U.S. CONSUMER PRODUCT SAFETY COMMISSION
5 RESEARCH PLACE
ROCKVILLE, MD 20850

March 7, 2022

STAFF'S EXAMINATION OF
HEATER POWER CORD PLUGS

Examination of Heater Power Cord Plugs

Exemplar - Sample 0446

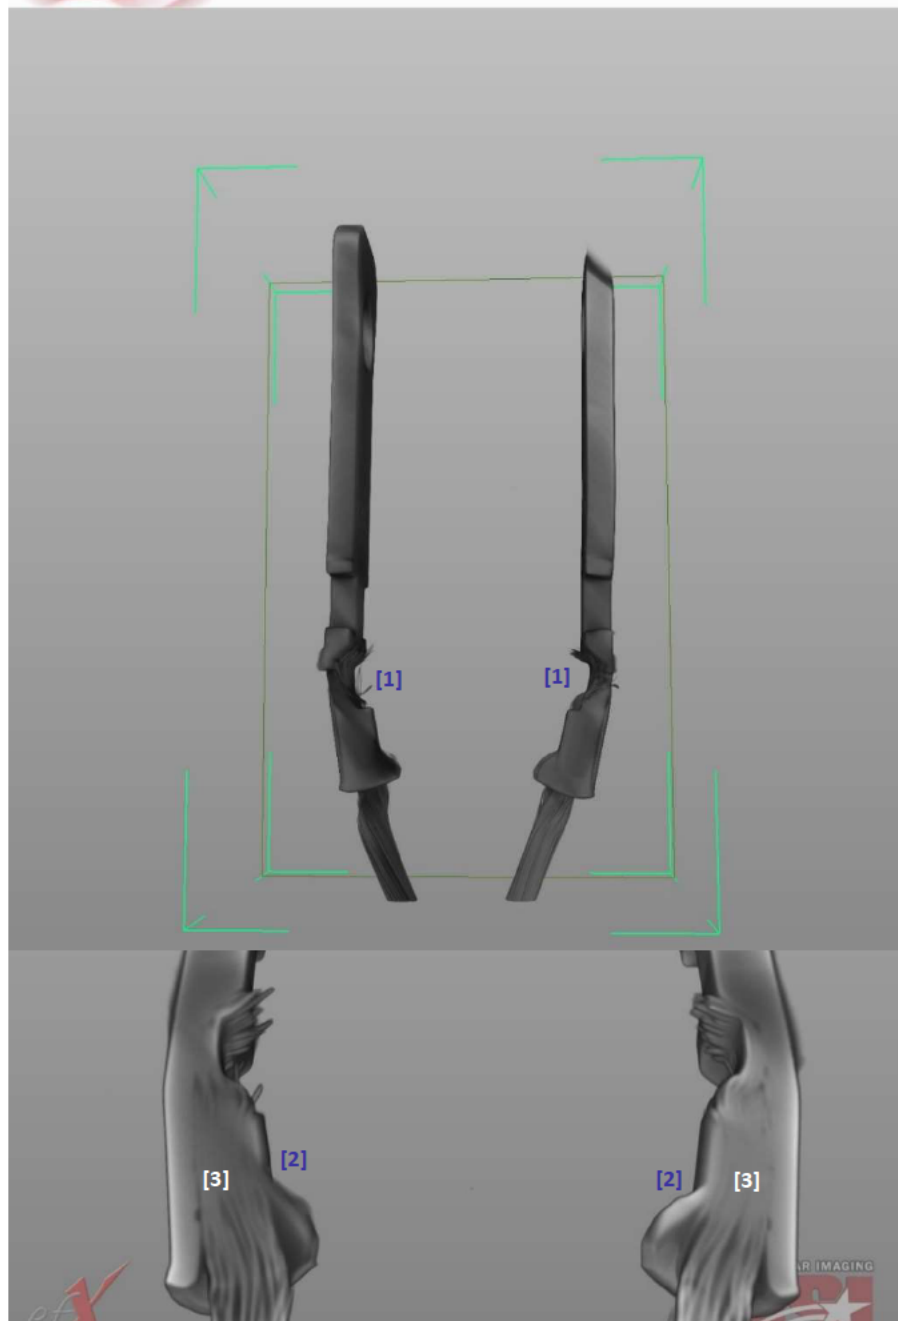
[1] For this sample, bar weld is used across the wire strands.

[2] Crimp location not centered resulting in excessive bell formation.

[3] Voids in the crimp barrel.

Exemplar - Sample 0689

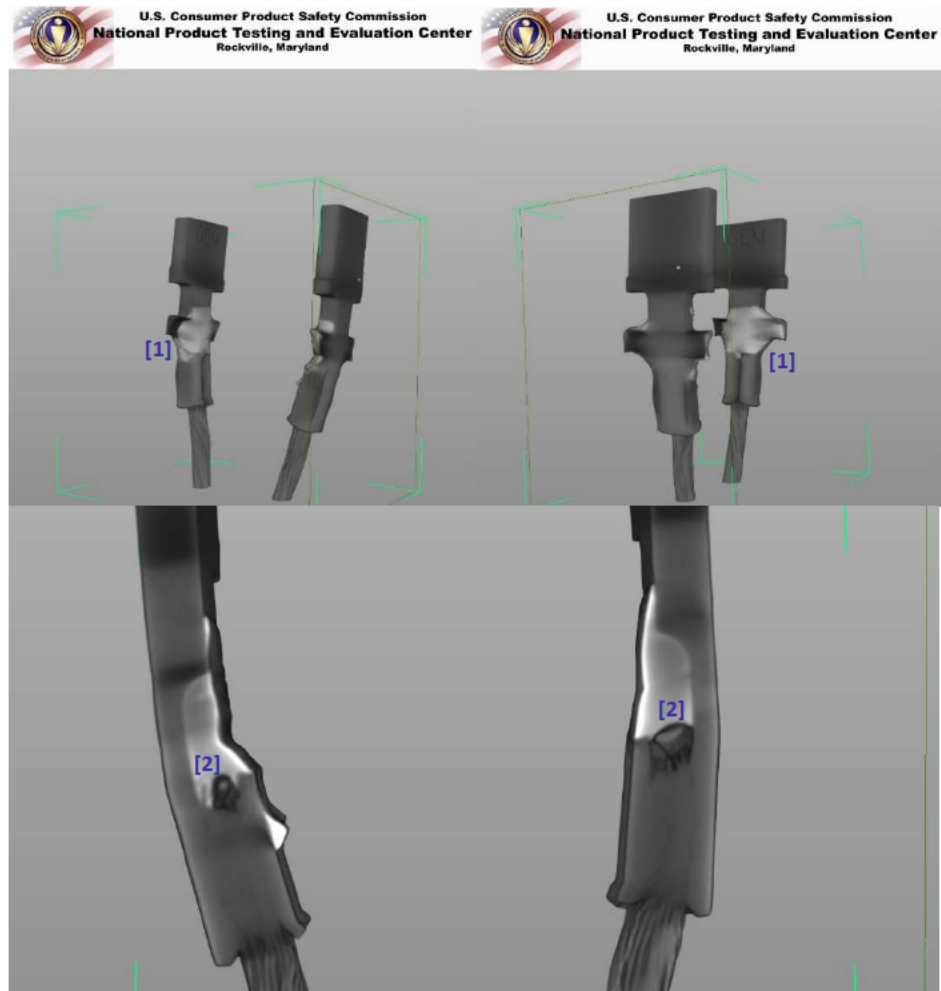
[1] For this sample, solder is used to bond wire strands to terminal surface.

[2] Voids in the solder.

Exemplar - Sample 0869

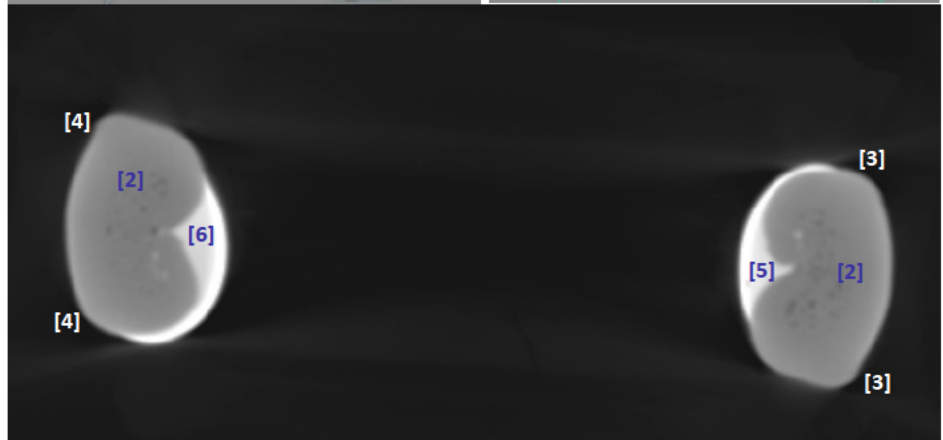
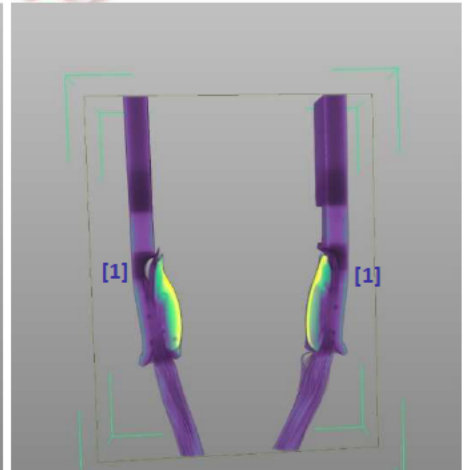
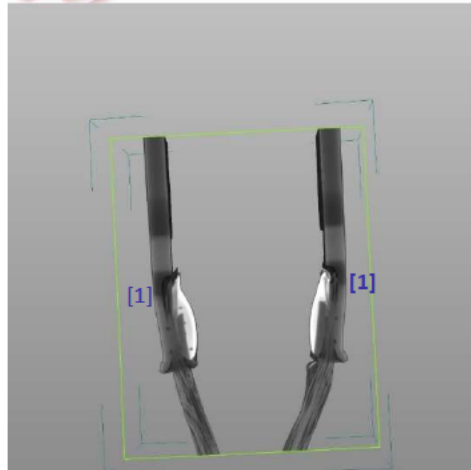
[1] Surface solder. Solder does not penetrate through wire strands to terminal surfaces.

[2] Voids in the crimp barrel.

[3] No burrs.

[4] Asymmetric crimp. Uneven burrs/extrusions.

[5] Uneven crimp barrel closure.

[6] Open crimp barrel.

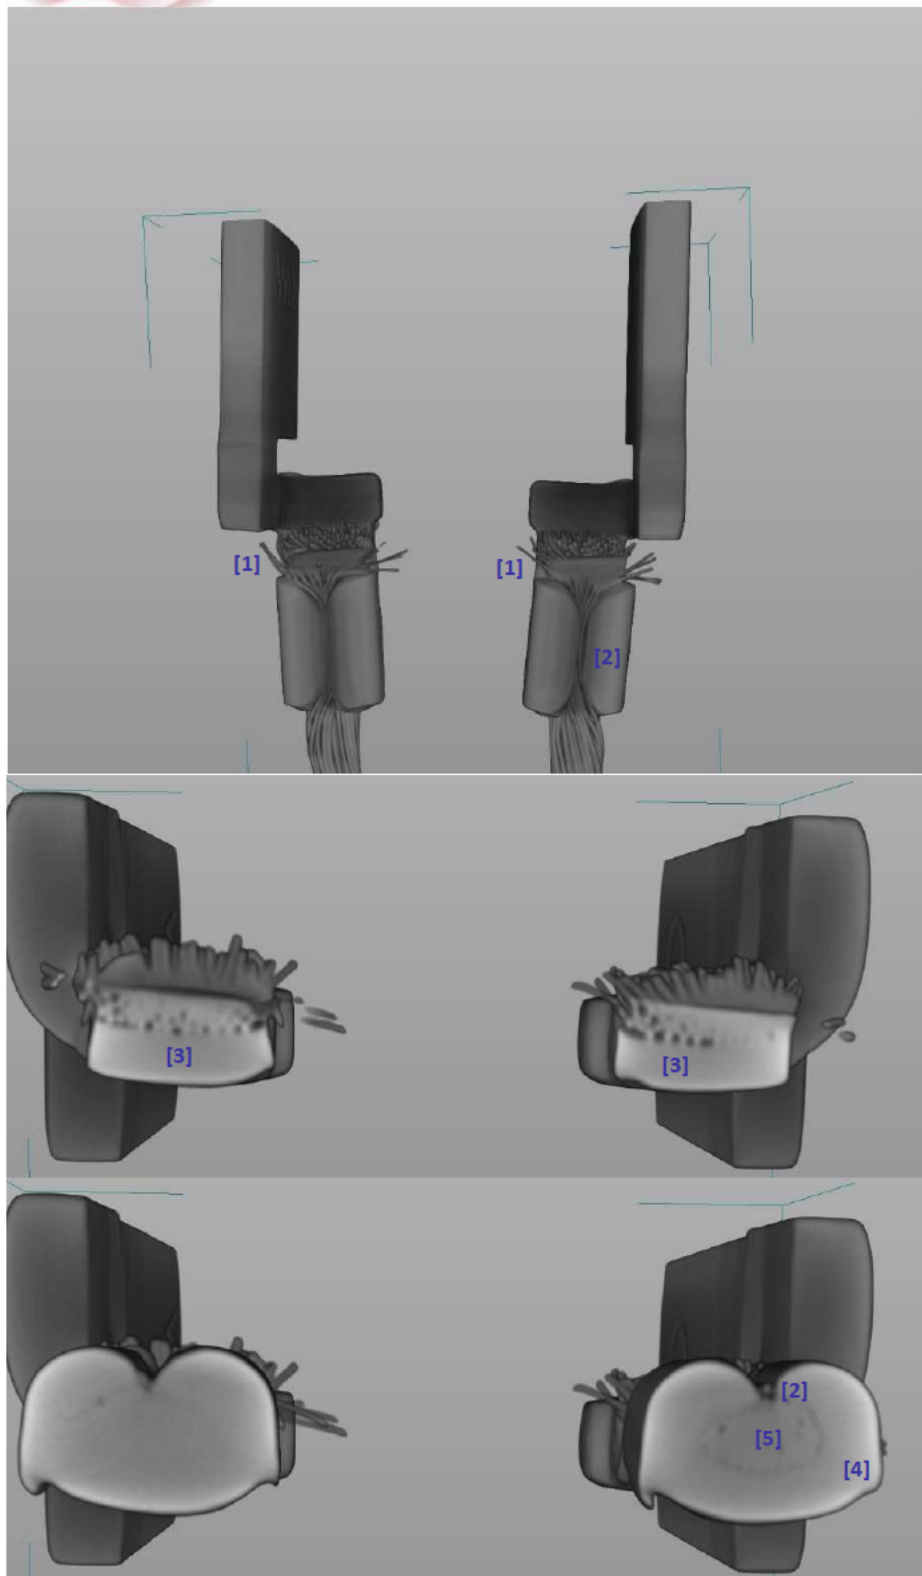
[1] For this sample, bar weld is used across the wire strands.

[2] Crimp barrel not fully closed.

[3] Voids in the weld. Not all the strands are welded to the terminal surfaces.

[4] Asymmetric crimp. Uneven burrs/extrusions.

[5] Voids in the crimp barrel.

Exemplar - Sample 0020

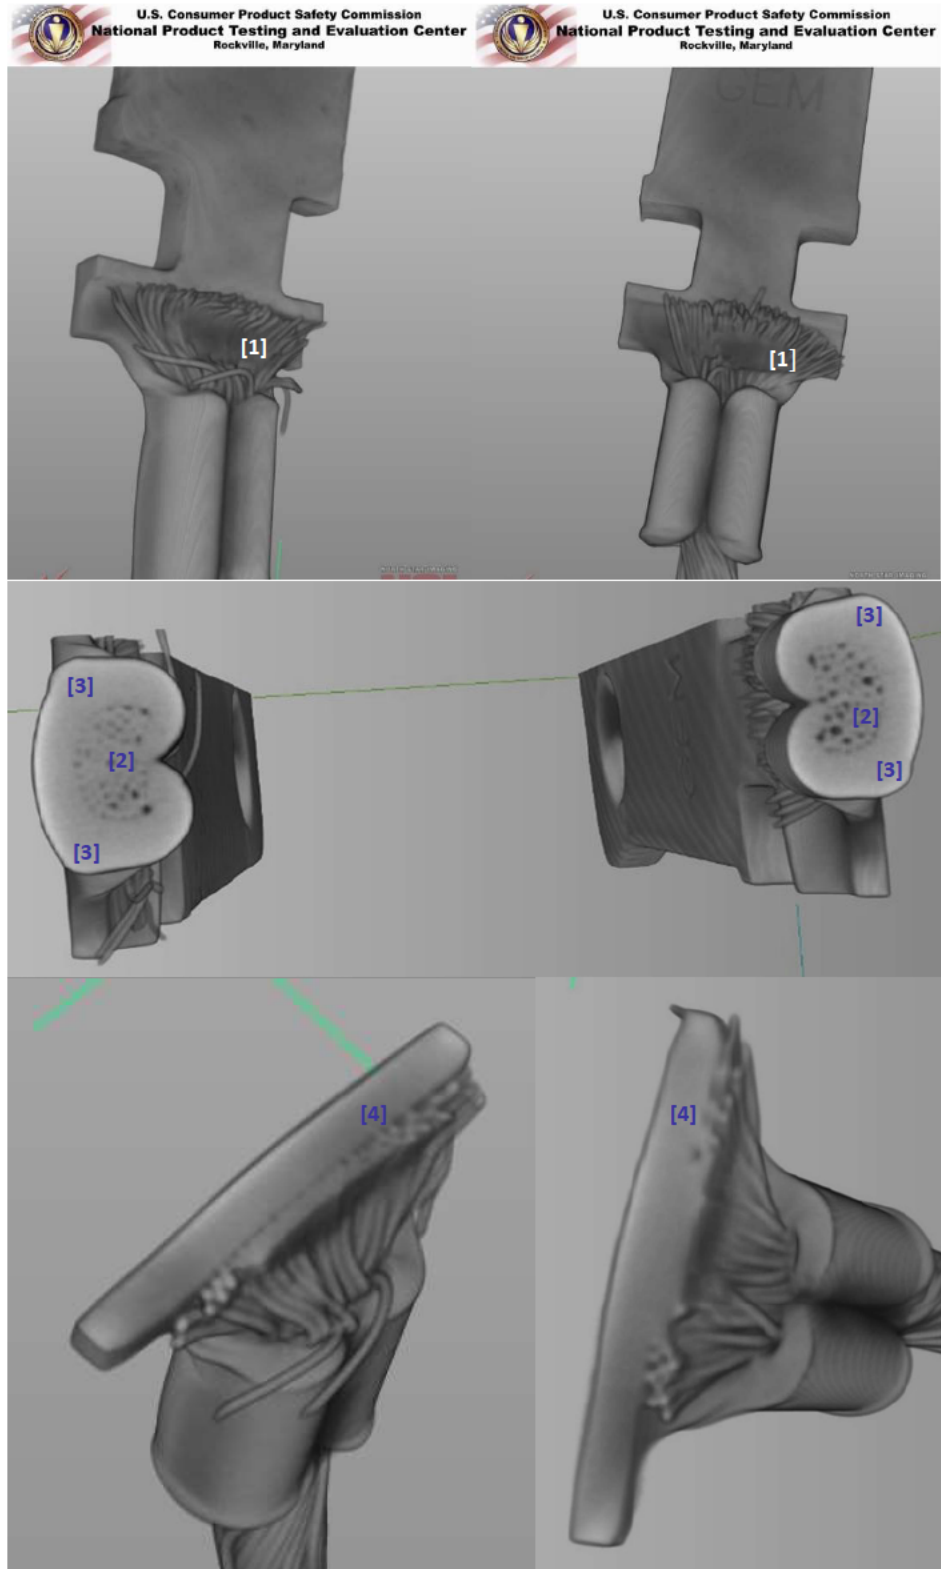
[1] Bar weld does not span the width of the wire strands.

[2] Voids in the crimp barrel.

[3] Asymmetric crimp. Uneven burrs/extrusions.

[4] Not all the strands are welded to the terminal surfaces.

Exemplar - Sample 0200

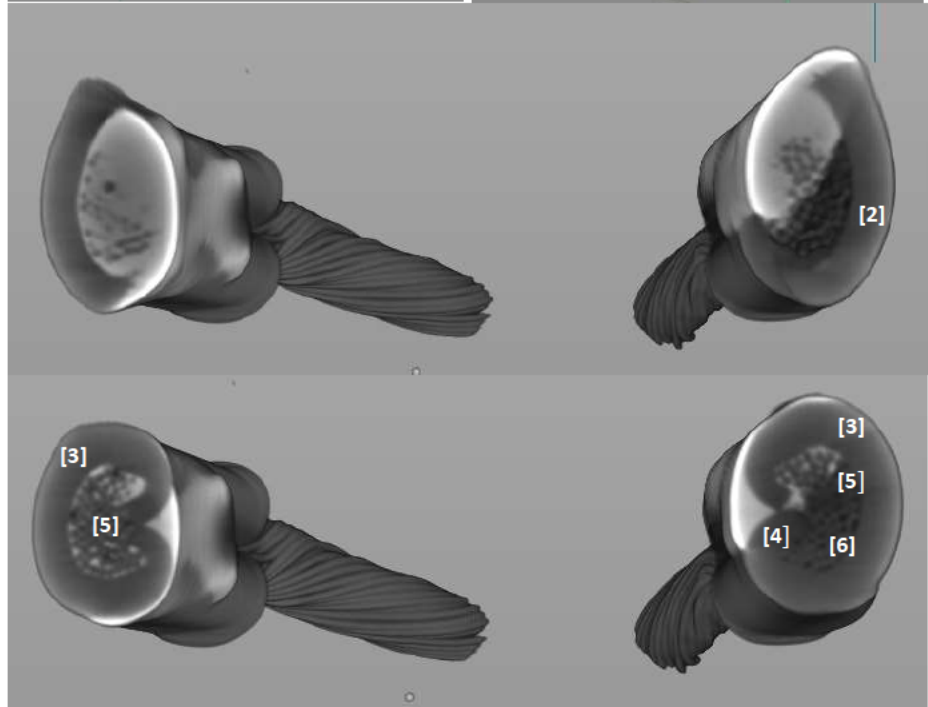
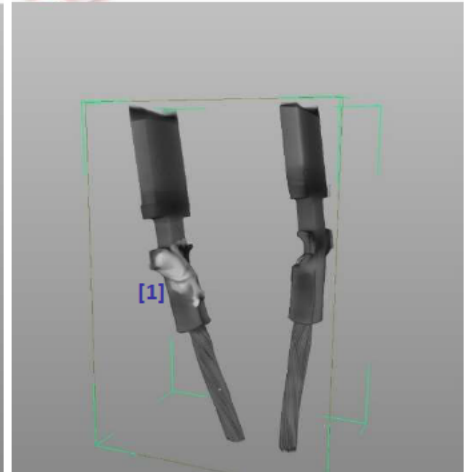
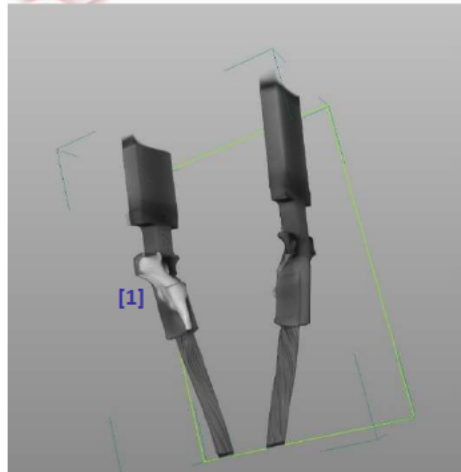
[1] Uneven solder.

[2] Solder does not cover all the strands and insufficient bonding to the terminal surfaces.

[3] No burrs/extrusions.

[4] Asymmetric crimp barrel.

[5] Solder flow into main crimp area is an indication of insufficient crimp pressure.

[6] Voids in crimp barrel.
